TOWN OF HORIZON CITY MEMORANDUM

SUBJECT: On the submitted **Final Subdivision Plat** application for **Verdancia Unit 1 (Case No. SDF25-0001)**, allow recording of the final plat prior to the completion of all required improvements secured by sufficient bond and to authorize the Mayor to sign the recording plat. Legally described as Being All of Tract 1, 2F, 3D, and 3H, and a Portion of Tract 2, 3 and 3B, Section 30, Block 78, Township 3, Texas and Pacific Railway Company Survey and Vacating Portions of Town of Horizon City Right-Of-Way, El Paso County, Texas. Containing 103.068 acres \pm . Application submitted by Applicant/Representative: CEA Group.

TOWN OF HORIZON CITY
Planning and Zoning Commission Staff Report

Case No.: SDF25-0001 Verdancia Unit 1 Final

PROPOSED TYPICAL 60' ROW STREET SECTIONS DETAIL
(DESERT SPRING DRIVE RESIDENTIAL COLLECTOR)
 SCALE: N.T.S.

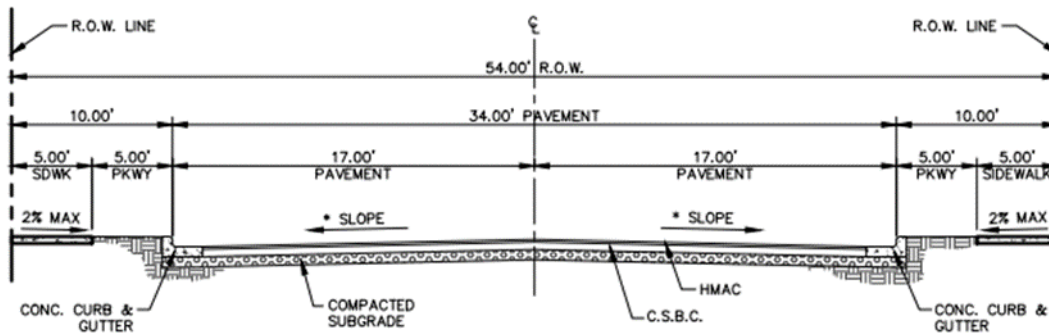
2. Modification to use a 60-ft wide street right-of-way residential collector, which consist of two 5-ft parkways, two 5-ft wide concrete sidewalks, a 40-ft wide pavement structure with curb & gutter. This right-of-way will be consistent with the adjacent existing residential collector street of Desert Springs Dr. to the west.

PROPOSED TYPICAL 54' ROW STREET SECTION DETAIL
(RESIDENTIAL SUB-COLLECTOR)
 SCALE: N.T.S.

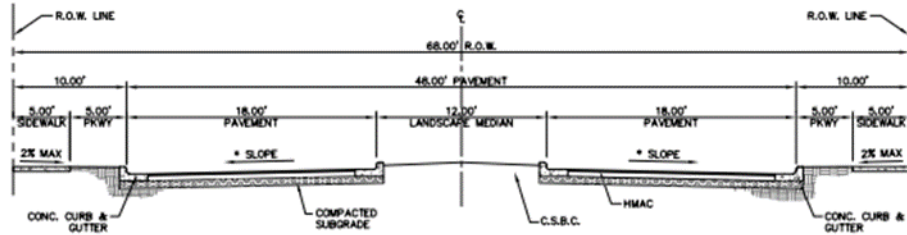
1. Modification from a 52-ft wide residential sub-collector street right-of-way to a 54-ft wide street right-of-way at all local residential sub-collector streets. The 54-ft street will consist of two 5-ft parkways, two 5-ft wide concrete sidewalks and a 34-ft wide pavement structure with curb & gutter.

PROPOSED TYPICAL 68' ROW STREET SECTIONS DETAIL @ ENHANCED ENTRANCES
(RESIDENTIAL COLLECTOR)
 SCALE: N.T.S.

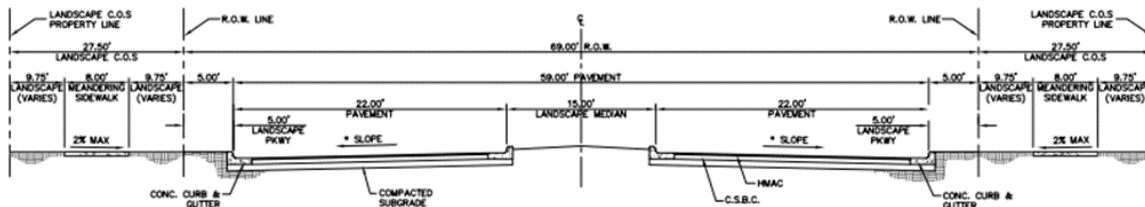
3. Modification to use a 68-ft wide residential collector at enhanced neighborhood entrances. The 68-foot street will consist of two 5-ft parkways, two 5-ft wide concrete sidewalks, two 18-ft wide pavement structures and a 12-ft raised landscape median with curbs & gutter. Landscape areas will be maintained by the HOA.

CUL-DE-SAC WITH LANDSCAPE ISLAND

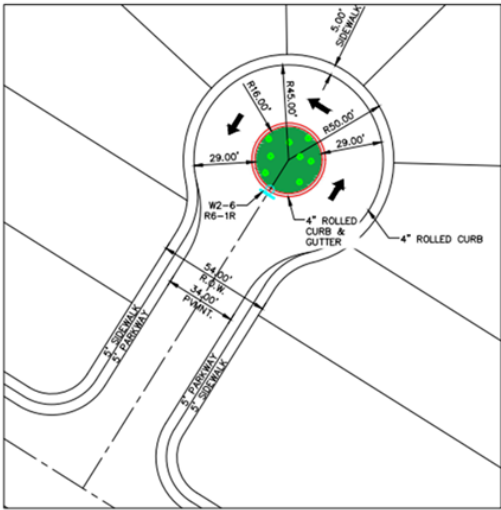
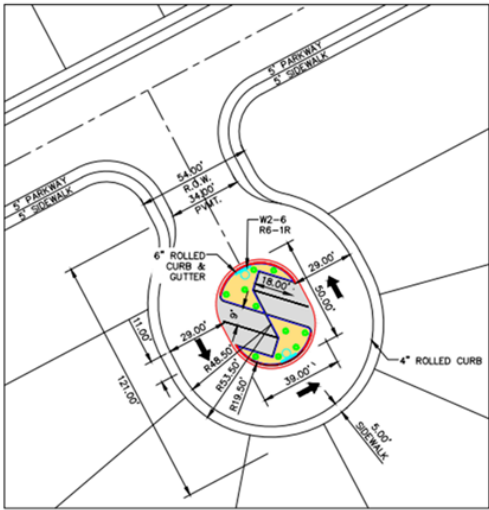
~~A modification letter from CEA dated August 21, 2024 requested a variance for a proposed 53.5' cul-de-sac. This cul-de-sac was not located in the Final Plat however a 48.50' cul-de-sac is shown. Please provide proof of approval for this variance on Curleaf Court with radio of 48.50'.~~

5. Modification from a 50-foot radius cul-de-sac street to a 50-ft and a 53 ½ -foot radius cul-de-sac with interior parking/landscape islands. The proposed cul-de-sac and parking/landscape islands will enhance the neighborhood character, reduce the impervious surface, and aid to eliminate typical cul-de-sac "stack" parking, while maintaining adequate room for emergency vehicle turning movement. Landscape areas will be maintained by the HOA.
